# SERVICE BULLETIN

ENGINE - LP TURBINE - PROVIDE A NEW LP TURBINE SHAFT THAT ELIMINATES NITRIDING ON THE SPLINE - CATEGORY CODE 7 - MOD.ENG-72-0117

V2500-ENG-72-0117

LP Turbine Shaft - Before and After Alteration  
Fig.1

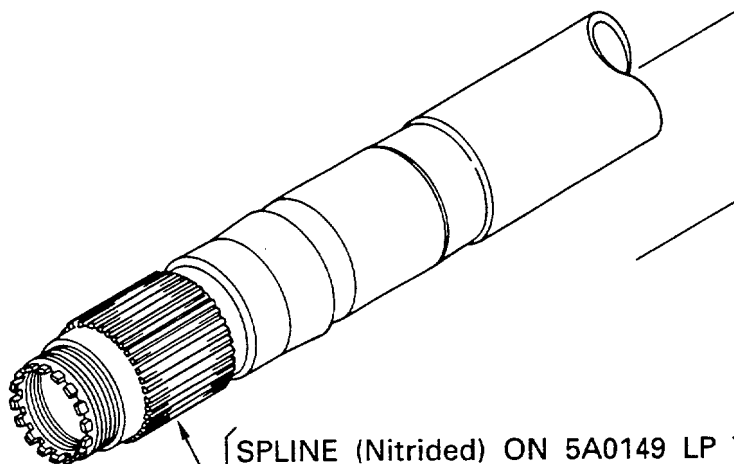
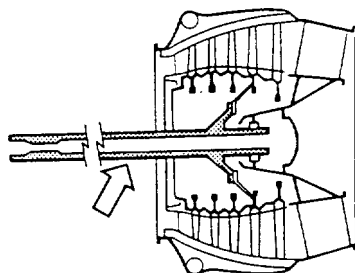
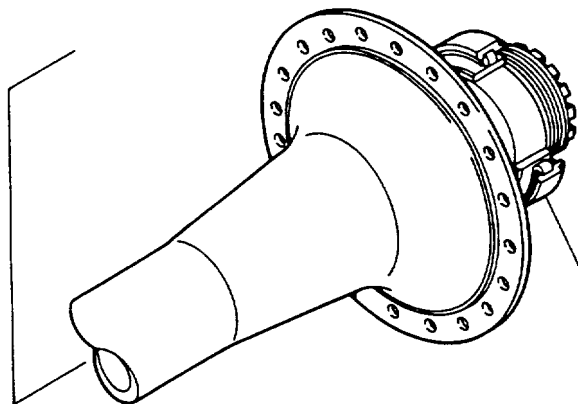
(a) New LP Turbine Shaft which is not nitrided on the spline has been introduced (See Figure 1).

SPLINE (Nitrided) ON 5A0149 LP TURBINE SHAFT  
- BEFORE ALTERATION

SPLINE (Not nitrided) ON 5A0892 LP TURBINE SHAFT  
- AFTER ALTERATION

- (1) Install 5A0892, LP Turbine Shaft, to the LP Turbine Module by the approved procedures in the Engine Manual, 72-50-00, Assembly-01, TASK 72-50-00-430-001 (Refer to 1.K. (2)).
